Central Station Main Works Project
CTMP Addendum 7 – Railway Colonnade Drive Rev 3

Construction Traffic Management Plan

Addendum 7

Railway Colonnade Drive Rev 3

Route of travel

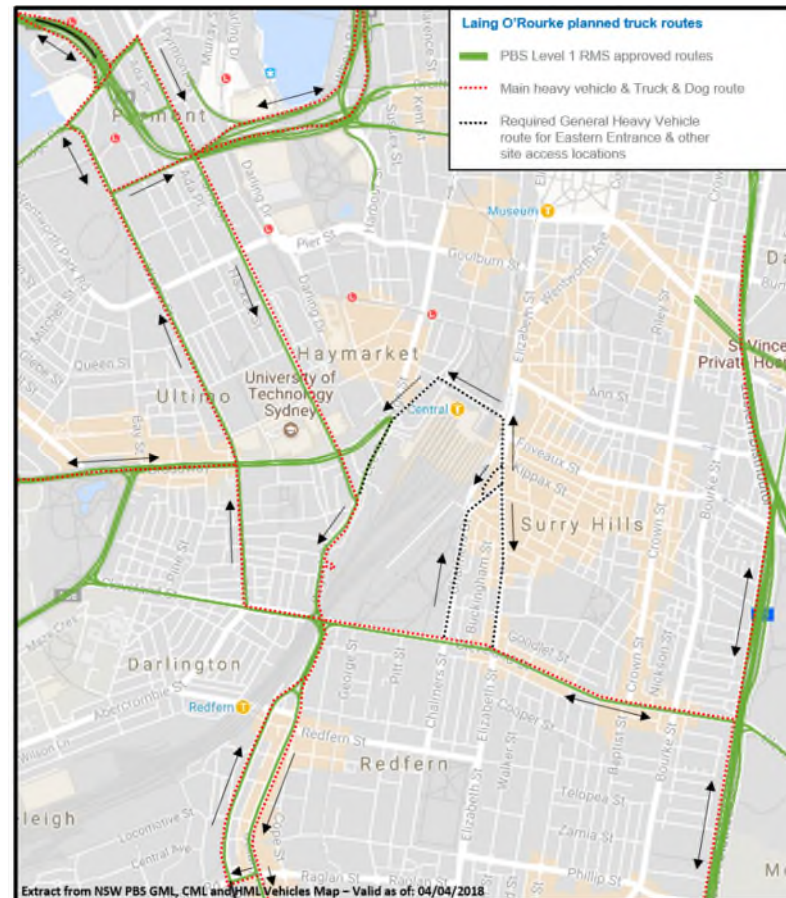
| DOCUMENT NO. | TITLE | VI | STATE | NO | DATE | COMPAN | RAISED BY | REVIEW DOC. NO. | DOCUMENT REF | DEED REF | COMMENTS / RESPONSE | COMMENT CATEGORY | CLOSED OUT |
|--------------------------------|---|------|-------|----|------------|--------|------------|--------------------------------|--------------|-------------|---|----------------------|------------|
| | | | | 05 | 19/06/2019 | HBI | APALUDETTO | SMCSWCSM-LOR-SMC-LM-PLN-000008 | Page 7 | Schedule E3 | 'Add. 7 cites heavy vehicle traffic (truck & dog) on Cleveland, Abercrombie, Wattle Sts. Are there routes for those vehicles, consistent with CTMP Ver. 2.5.1 Mar 19 Sec. 7? Alternate routes proposed, approved for use? Is a consistency assessment required? | Potential Compliance | Non-N |

| Item No | Contract | Contractor | Doc Rev | Requirement Ref (COA or CTMP) | Stakeholder | Reviewer | Date | Item Description, Refs, Revs | RMS comment | Contractor Response | Date | Response Status | RMS response |
|---------|----------|------------|---------|-------------------------------|-------------|----------|-------------|------------------------------|--|--|------------|-----------------|--------------|
| 5 | CSM | LORAC | 1.02 | | RMS | CM | 09-Sep-2019 | App | A map of the heavy vehicle routes beyond the site access/egress should be included in this submission. | Added | 09.09.2019 | | |

| Sydney Metro City & Southwest : Document Review | | | | | | | | | | HBI Ref: |
|---|----------|------------|-------------|--|--|---|---|------------|-------------------|----------|
| Route of travel | J.Coles | SCO | 09-Sep-2019 | | Please provide the haulage routes relating to this operation. | | A separate drawing has been added | 09.09.2019 | | |

| DOCUMENT NO. | TITLE | VI | STATE | NO | DATE | COMPAN | RAISED BY | REVIEW DOC. NO. | DOCUMENT REF | DEED REF | COMMENTS / RESPONSE | COMMENT CATEGORY | CLOSED OUT |
|--------------------------------|---|------|-------|----|------------|--------|------------|--------------------------------|--------------|-------------|---|----------------------|------------|
| | | | | | | | | SMCSWCSM-LOR-SMC-LM-PLN-000008 | Page 7 | Schedule E3 | The route shown in Add. 7 is as per figure 2 in the CTMP Ver. 6 May 2019 | Potential Compliance | Non-N |
